AGENDA PLANNING COMMISSION MEETING

November 3, 2015

- A. 841 San Bruno Avenue West** (APN: 020-072-290 and 020-072-330)
Zoning: A-R (Administrative and Research)

**PLANNING COMMISSION
 STAFF REPORT
 AGENDA ITEM NO. 5A
 November 3, 2015**

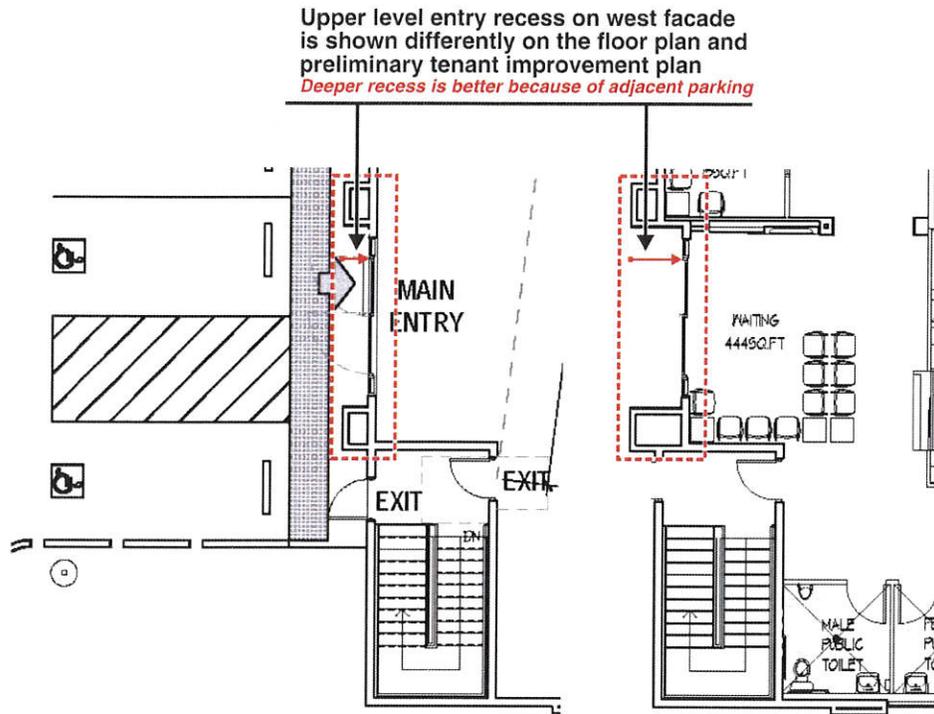
2. The floor plan for the east entry at the upper level is shown with different recessed depths for the entry doors on the Upper Level Floor Plan and the Preliminary Tenant Plan.

Recommendation: Modify the Upper Floor Plan to provide the greater depth of entry at the recess. This would result in a stronger entry, and would assist slightly in addressing the concern raised in the first comment #3 bullet below.

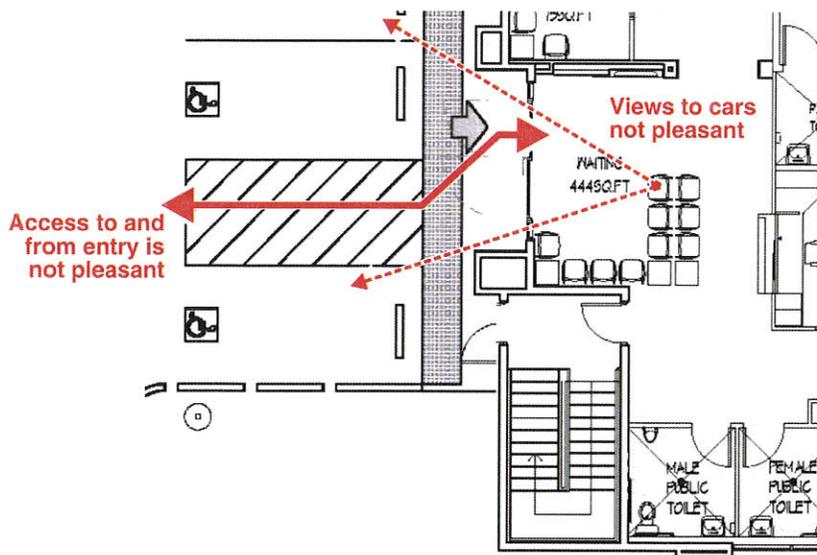
3. The east entry is quite awkward for the following two reasons.
- The pedestrian path linking the entry and the parking lot is not very pleasant with very close proximity to parked cars.
 - Patients in the waiting room would have only a view of the fronts of parked cars.

Recommendation: Consider a slightly smaller building to allow either a landscaped buffer between the building and the parking lot or the elimination of some parking spaces to provide a landscaped area were some parking is currently located.
